19	BULL 015G - VE	10/15/2013
15	BULL 015B - PRE-AWARD	08/20/2013
REVISIONS:		
		DATE

DRAWING TITLE
BLDG 2 OVERALL THIRD FLOOR PLAN

PROJECT TITLE
SLYVCS REPLACEMENT MEDICAL
CENTER PROJECT

PROJECT NUMBER
629-HS2-401

1 BLDG 2 OVERALL THIRD FLOOR PLAN
SCALE: 1/16" = 1'-0"

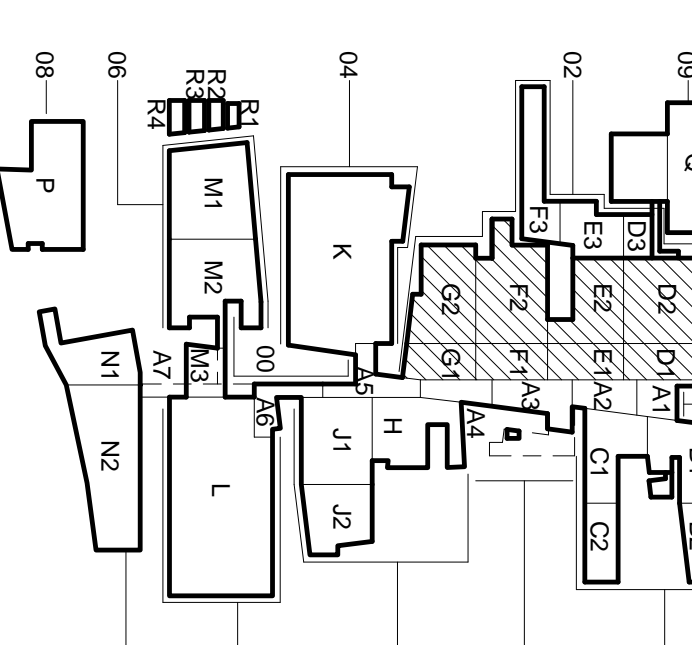
REFER TO THE FOLLOWING SKETCH FOR CHANGES:
SK-8-4-NJ 2A1003

SEE RFI 03824 FOR CONTROL JOINT LOCATION

MATCH LINES AND/OR MATCHLINE TAGS
REMOVED THIS SHEET
